TEKTRONIX INTERNAL USE ONLY

June 19, 1981
Issue 11-11

TABLE OF CONTENTS

FIGURE 1

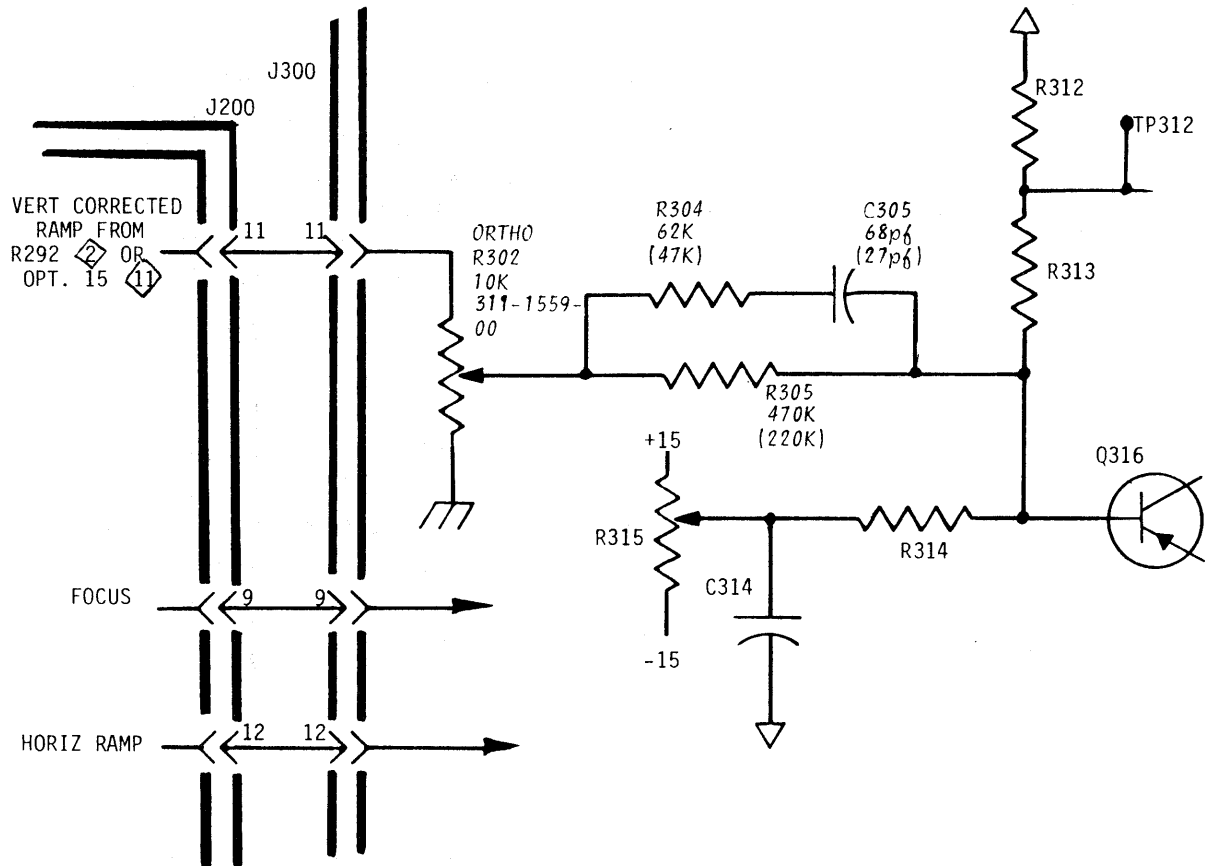
A number of changes have been made to the 634 yoke driver boards to improve reliability and performance. The new part numbers of the boards are 670-5594-03 for the standard product and 670-6122-02 for the 634 Option 15.

To improve geometry, an ORTHOGONALITY adjustment is added to both boards. However, the values of the added components differ between the two boards. Refer to Figure 1 for the values of the new parts. Those values in parentheses are for the Option 15 board. The new ORTHO control is best adjusted after step D5.h of the manual calibration procedure; that is, after the horizontal linearity adjustment.

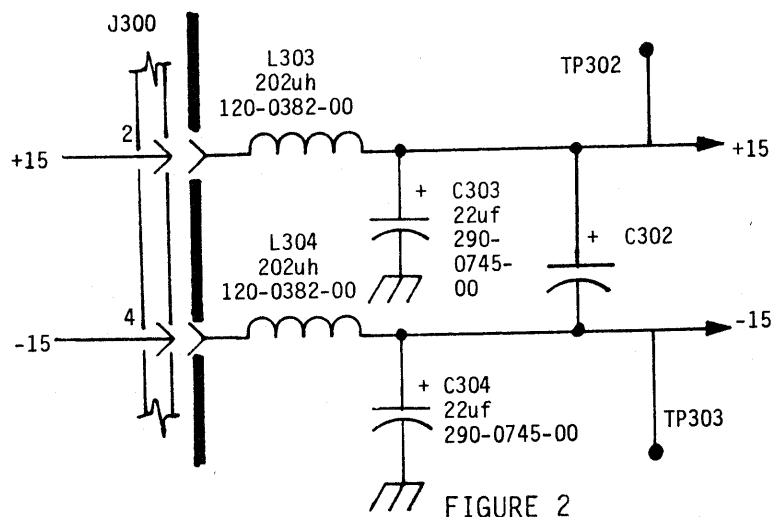
The new standard yoke driver board includes the filtering components C303, C304, L303, and L304 needed for the Option 20 product. As a result, the 670-7004-00 will no longer be produced.

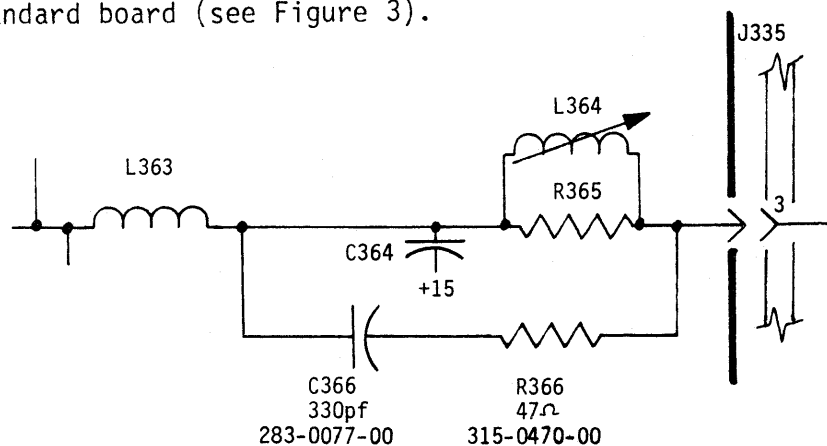
Several other changes are made to the standard yoke driver board. Resistor R380 is reduced in value and R386 is increased (see Table I). These values are changed to prevent an overcurrent condition. Resistor R352 is changed to an Allen-Bradley type component to prevent board damage in the event of an overcurrent failure. Capacitor C324 is changed from P.N. 283-0204-00 to 283-0003-00 to provide commonality between the standard and Option 15 boards. The damping network previously used on the Option 15 is now added to the standard board (see Figure 3).

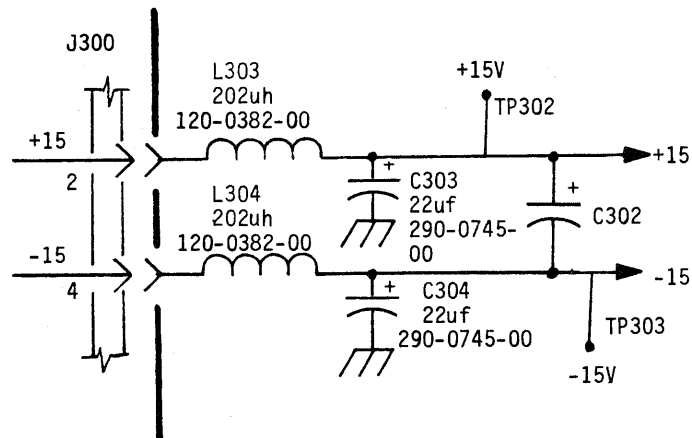
The 634 Option 20 was known to transmit noise and horizontal line rate interference down the customers' power supply lines. To correct this, filtering was necessary on the +15V and -15V supply inputs.

Modification 39769 solved the problem by establishing the 670-7004-00 yoke driver circuit board assembly. This board is identical to the standard 670-5594-02 except that line filtering is effected by the addition of two toroidal coils and two electrolytic capacitors.

311-1941-00

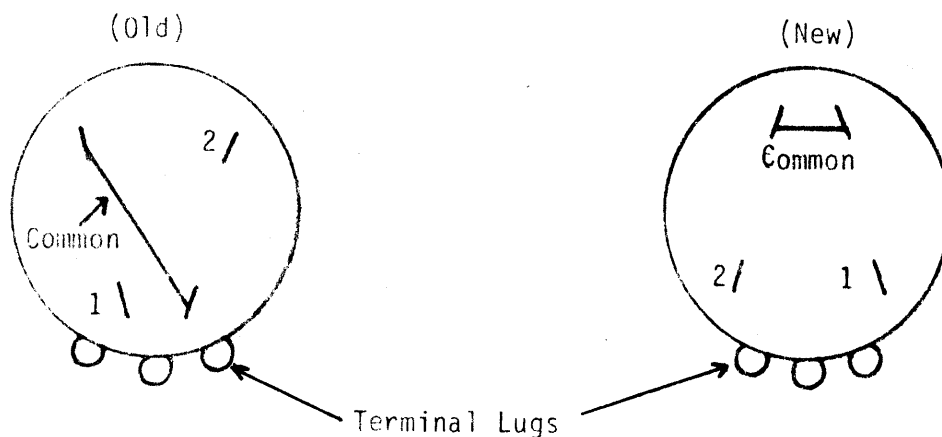
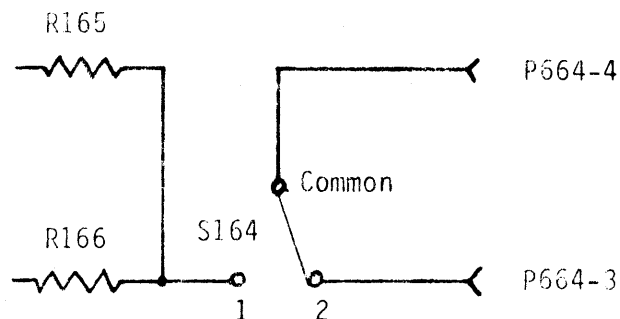
The vendor for the threshold switch, Part Number 311-1941-00, found it necessary to invert the switch's body. All electrical functions remained the same, but there were some alterations made to the pin configuration which will affect the wiring. However, the part number remained the same for both versions.

The following diagrams will illustrate the differences between these two pin configurations.

FIGURE 1'

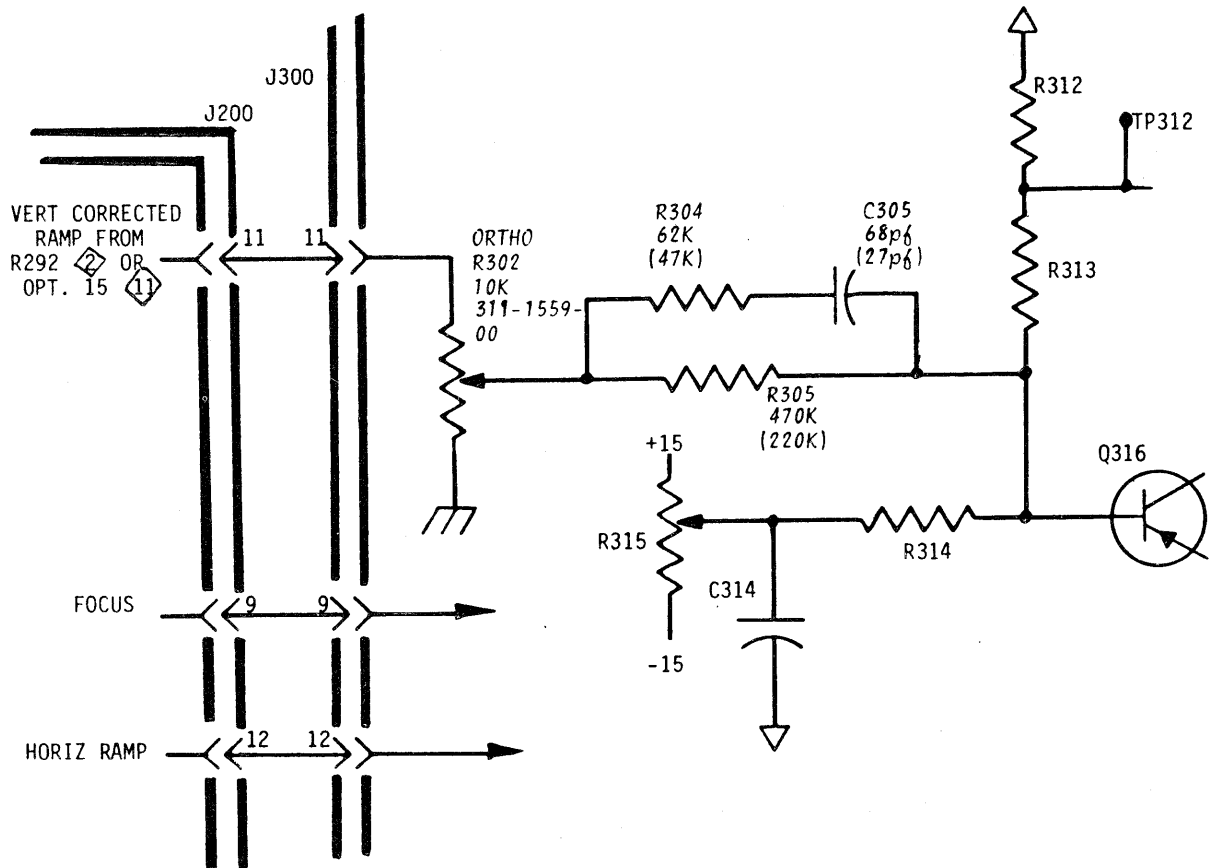
A number of changes have been made to the 634 yoke driver boards to improve reliability and performance. The new part numbers of the boards are 670-5594-03 for the standard product and 670-6122-02 for the 634 Option 15.

To improve geometry, an ORTHOGONALITY adjustment is added to both boards. However, the values of the added components differ between the two boards. Refer to Figure 1 for the values of the new parts. Those values in parentheses are for the Option 15 board. The new ORTHO control is best adjusted after step D5.h of the manual calibration procedure; that is, after the horizontal linearity adjustment.

FIGURE 2

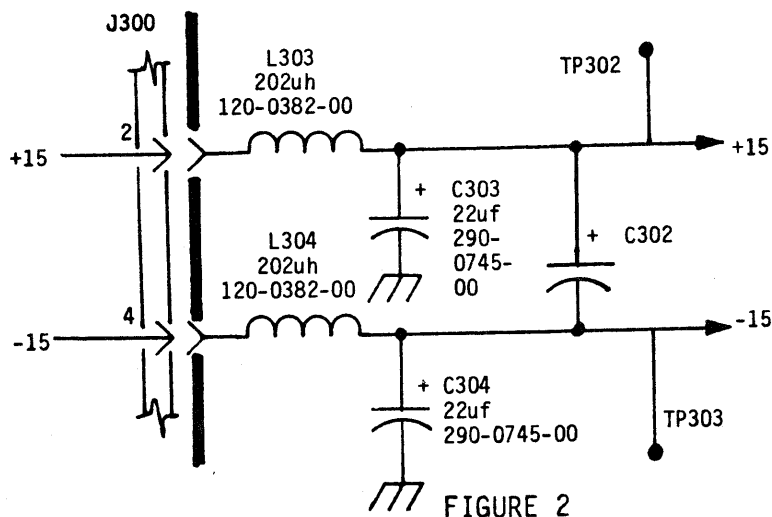
The new standard yoke driver board includes the filtering components C303, C304, L303, and L304 needed for the Option 20 product. As a result, the 670-7004-00 will no longer be produced.

FIGURE 3

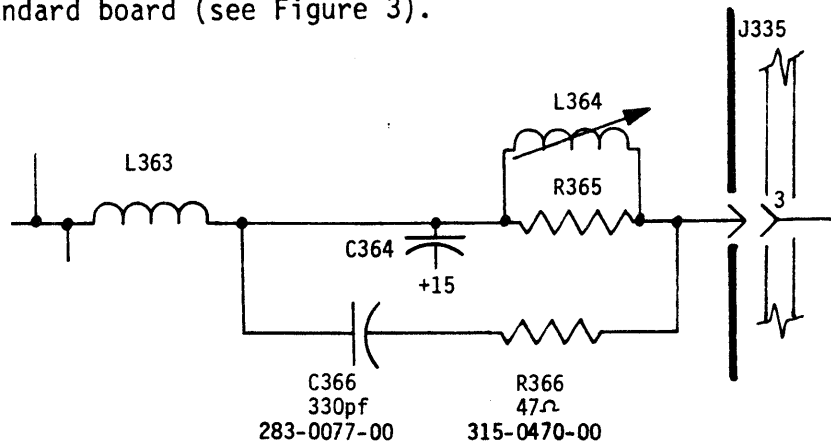
Several other changes are made to the standard yoke driver board. Resistor R380 is reduced in value and R386 is increased (see Table I). These values are changed to prevent an overcurrent condition. Resistor R352 is changed to an Allen-Bradley type component to prevent board damage in the event of an overcurrent failure. Capacitor C324 is changed from P.N. 283-0204-00 to 283-0003-00 to provide commonality between the standard and Option 15 boards. The damping network previously used on the Option 15 is now added to the standard board (see Figure 3).

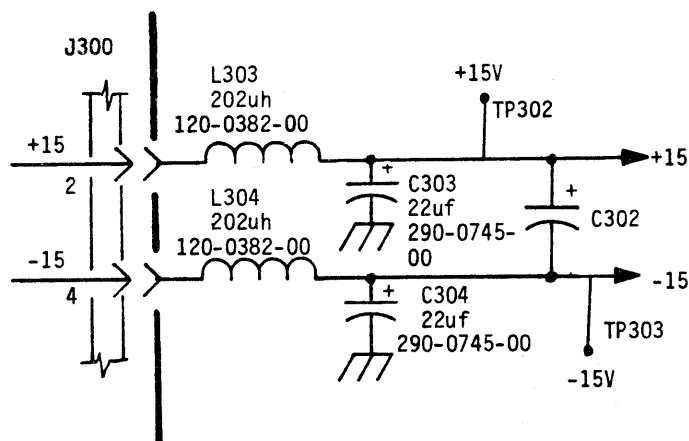
The 634 Option 20 was known to transmit noise and horizontal line rate interference down the customers' power supply lines. To correct this, filtering was necessary on the +15V and -15V supply inputs.

Modification 39769 solved the problem by establishing the 670-7004-00 yoke driver circuit board assembly. This board is identical to the standard 670-5594-02 except that line filtering is effected by the addition of two toroidal coils and two electrolytic capacitors.

S-3200 2943 CYCLE LENGTH M#42466

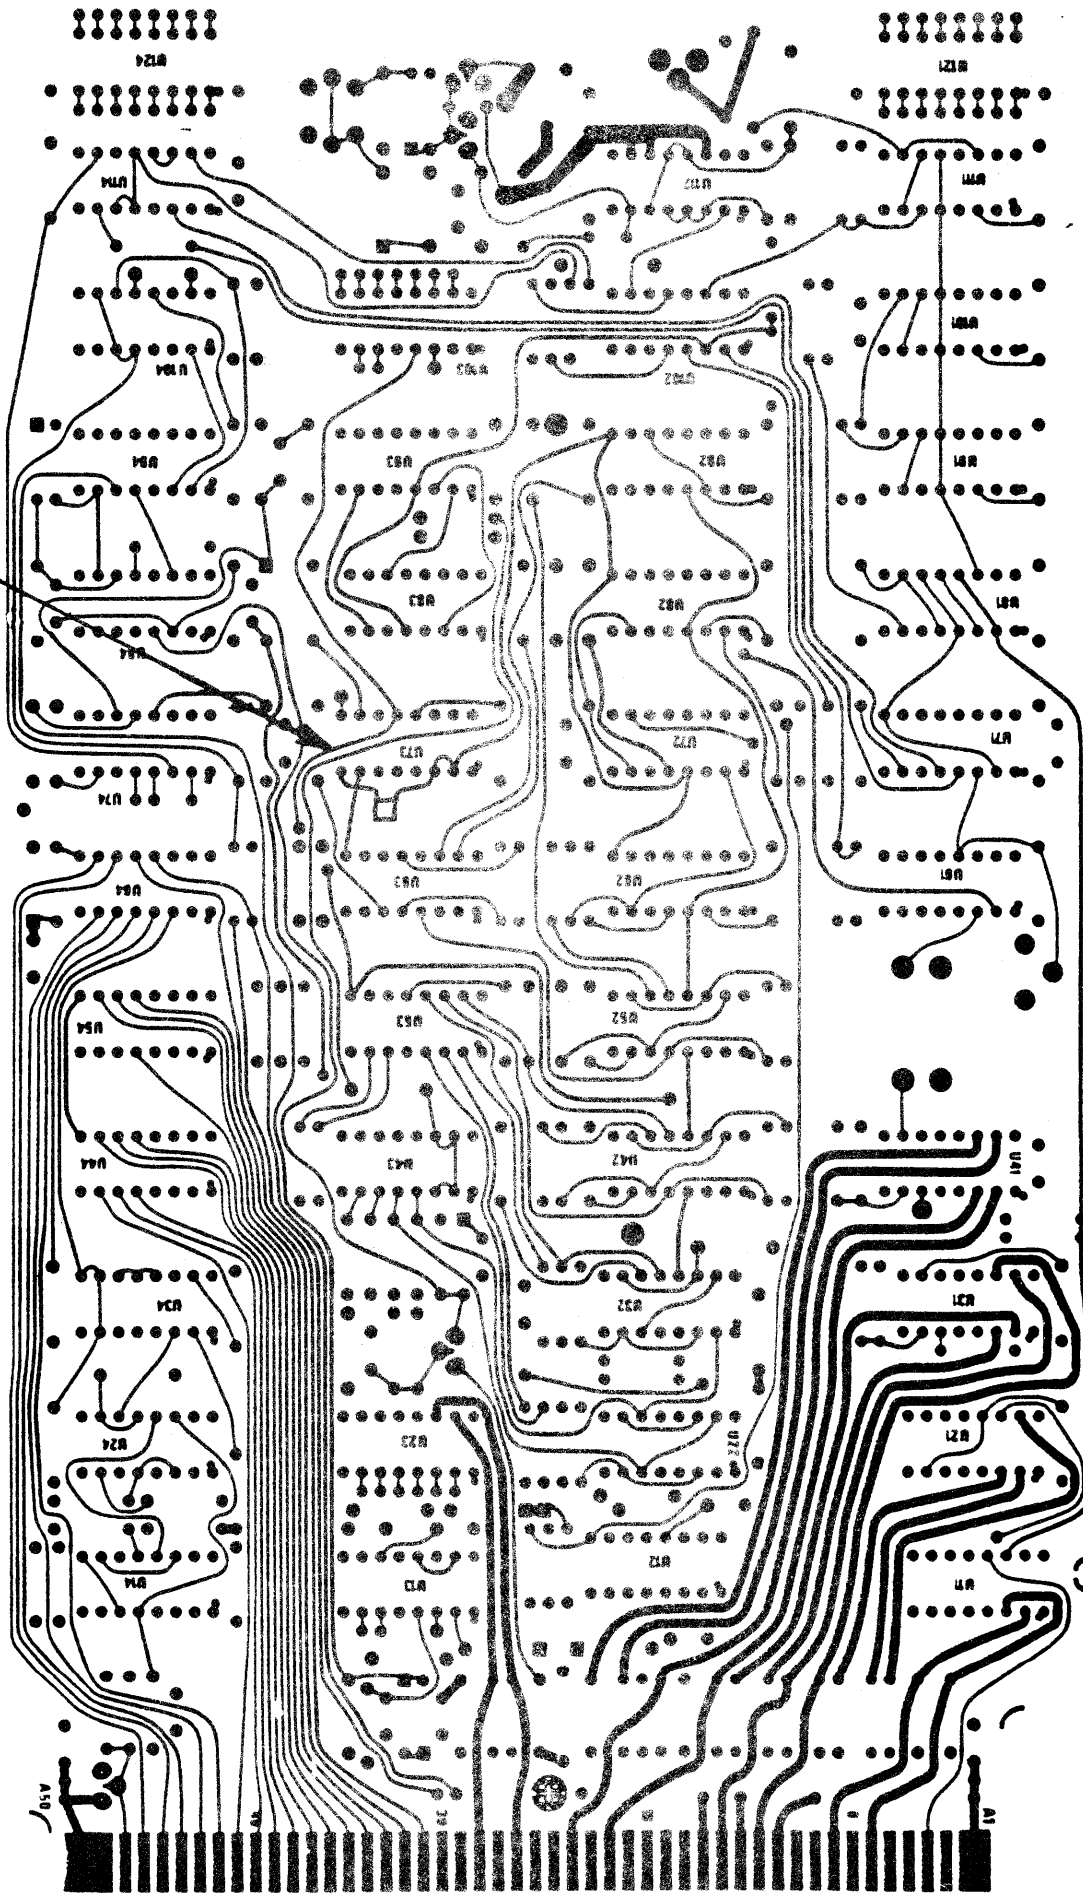
Cycle length counter bits may toggle prematurely due to a negative glitch in the "Inhibit" signal. This premature count may cause cycle length errors. The signal is enhanced by adding a 51pf, 5% 200V capacitor (283-0107-00). Component designation will be C173. Connect C173 from U73 pin 3 to pin 8. The leads of the capacitor should be insulated with sleeving (162-0581-00). Add the capacitor on the back of the board as shown in the diagram. The assembly number of the cycle length card will change from 670-5383-03 to 670-5383-04.
